1NQ, TARIFF STREET, MANCHESTER HSE COMMENTS

GM2001/hz/15ax
17th January 2023

Following issue of the Fire Statement Form of 1NQ, Tariff Street, Manchester (Ref: 13hzl-dpp Fire Statement Form – Tariff Street, dated 29th November 2022), HSE have carried out a review of the form.

This report presents responses to the comments raised by HSE (ref: pgo-2456, dated 11th January 2023). HSE comments are provided in blue.

Figure 1 Firefighters' Point of Entry

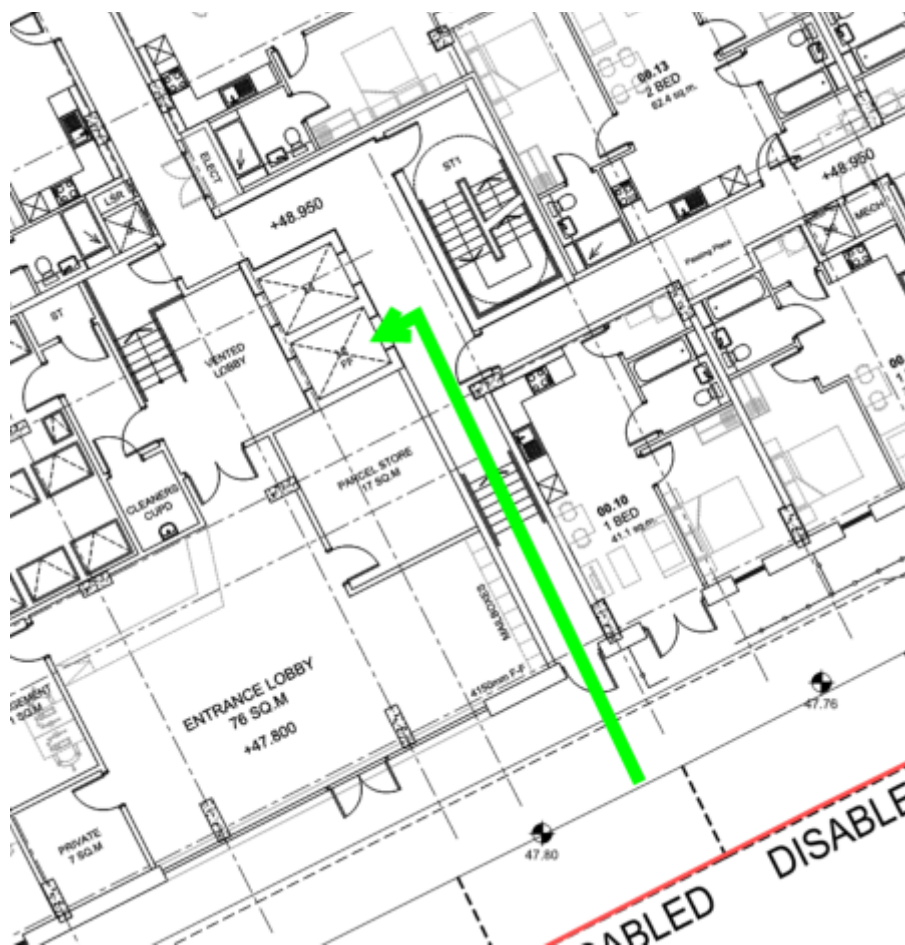
Section 2.1: The ground floor drawing identifies the installation of a dual-entry firefighting lift. The fire safety standard states that the use of dual-entry firefighting lifts is not recommended in residential buildings. Design changes necessary to provide suitable firefighting lifts for firefighter safety during their operations should not affect land use planning considerations in this instance, but may be identified at later regulatory stages

JH response: A fire engineering approach has been/will be further developed to mitigate any risk to firefighters using the lift. These are:

- Each point of entry will be approached by a smoke vented lobby/corridor.
- The spaces opening into the smoke vented lobby/corridor will be sprinklered.
- The smoke vented lobby will be provided with the same standard of fire resisting as a typical firefighting shaft i.e. enclosed in 120 minutes fire resisting construction.
- Entry into the firefighting shaft at ground floor will be from the dedicated corridor from Tariff Street i.e. there will be additional signages to aid firefighters (see Figure 1 below)
